From: <mkleisure@firstenergycorp.com>
To: <jbh1@nrc.gov>
Date: 8/23/02 2:01PM
Subject: RE: NRC Request re: Cavity Mold

Attached is an email responding to a Steve Long request forwarded to Dale Wuokko via Stephen Sands on 8/21. Please forward this information to Mr. Long. I have also included (below) the powerpoint slide and the word doc referred to in the attached email.

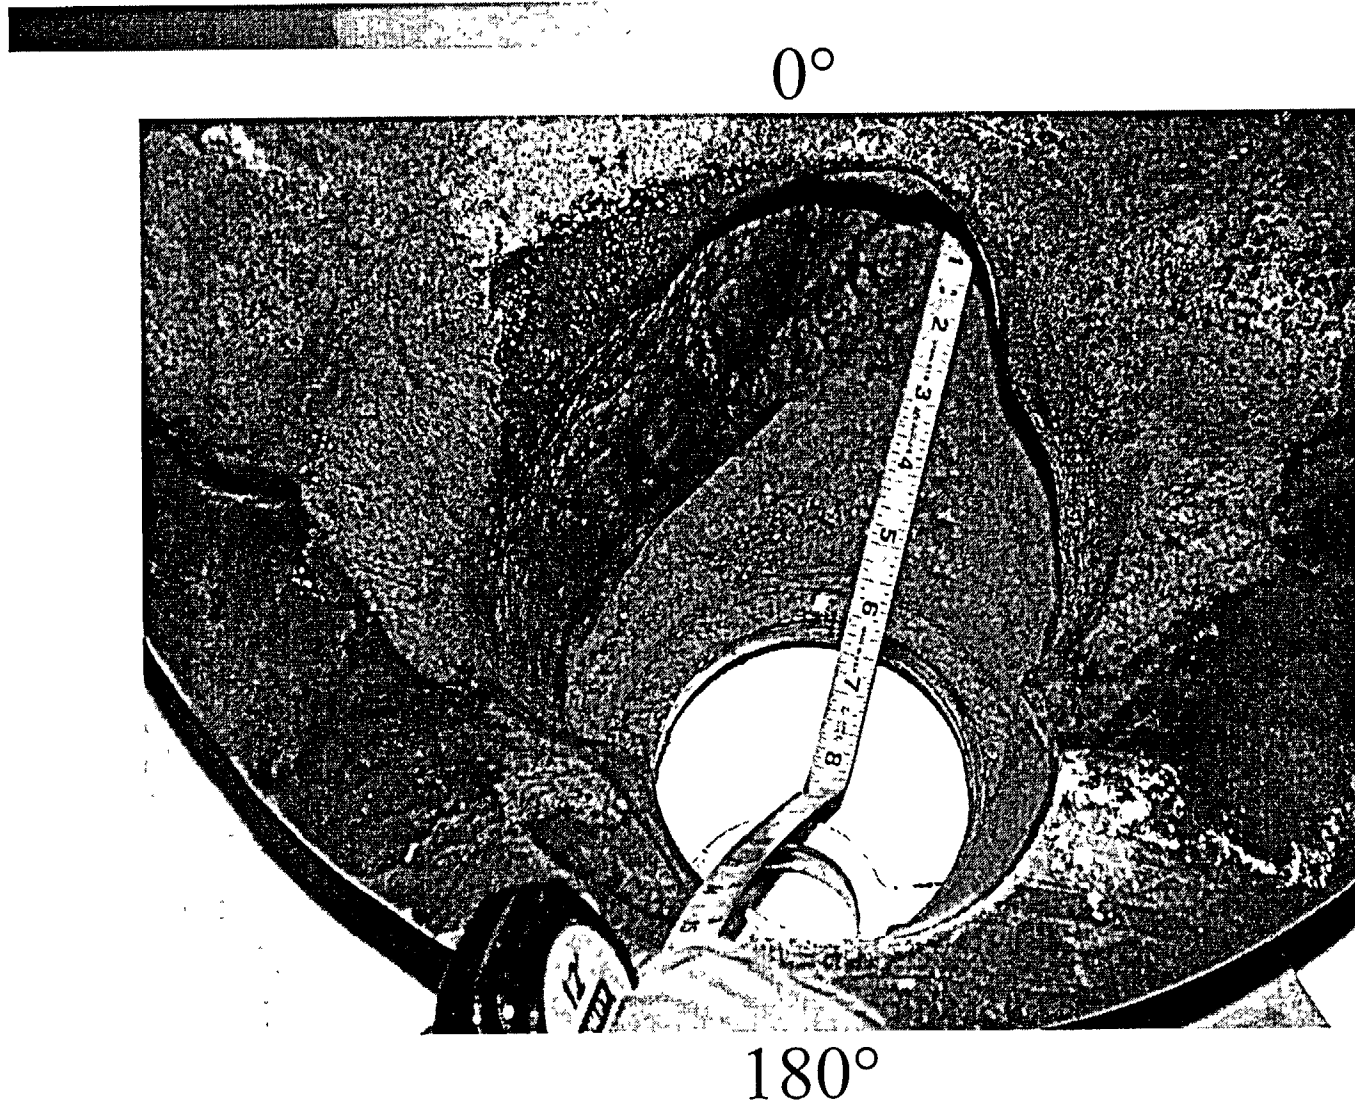
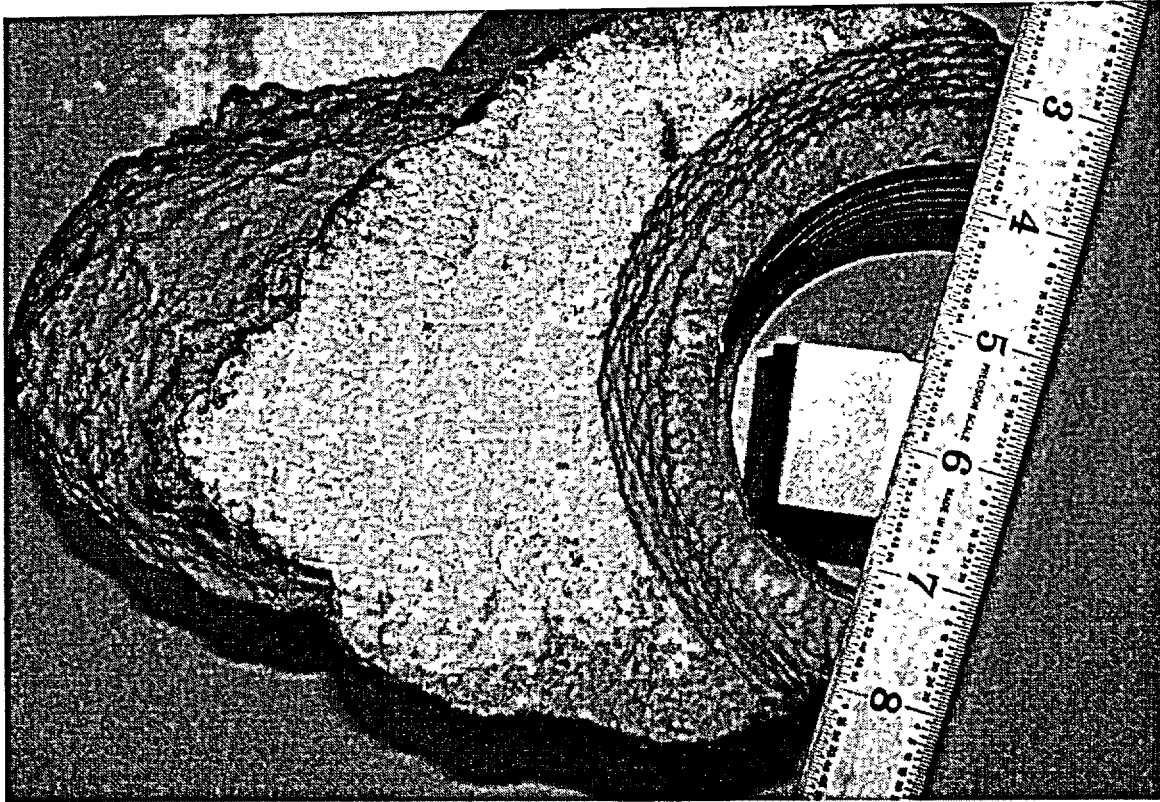
Based on the photos (particular slide #12) in the 6/17/02 presentation at BWXT and photos for the exposed cladding area measurement (word doc in my 8/7/02 email to you), the shortest distance from the nozzle #3 O.D. to the extremity of the cavity (i.e. the farthest point of the nose) is estimated to be 5.9+/- 0.2 inch.

I just faxed you a couple of pages regarding an NRC request on the maximum dimension from the nozzle to the nose of the cavity. Please call me when you've had a chance to review the fax.

Top View – Damaged CRDM Opening

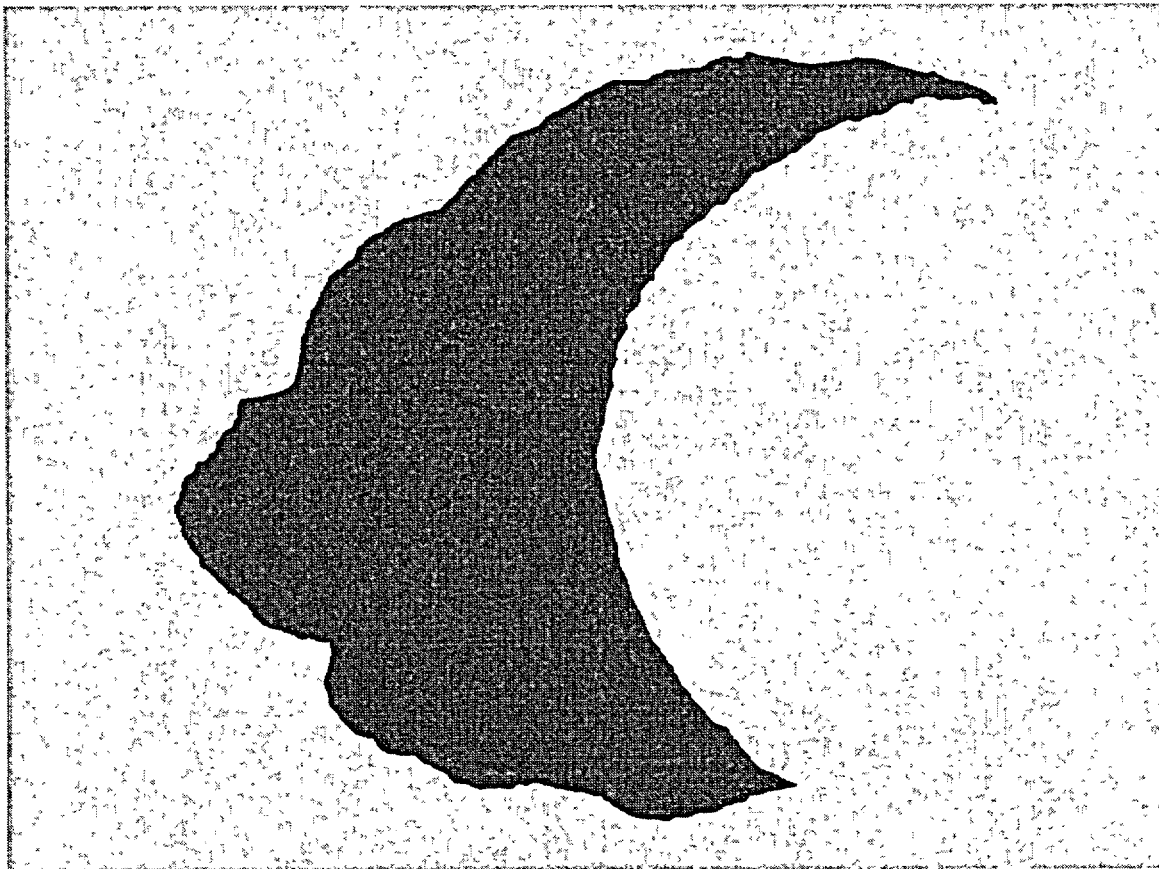
Magnification: $6''/3.82'' = 1.57X$

Area of photo: $(6'')(1.57) \times (4.5'')(1.57X) = 66.55 \text{ in}^2$

Area fraction of exposed cladding: 25.95% (by image analysis software)

Area of exposed cladding: $(66.55 \text{ in}^2)(.2595) = 17.27 \text{ in}^2$
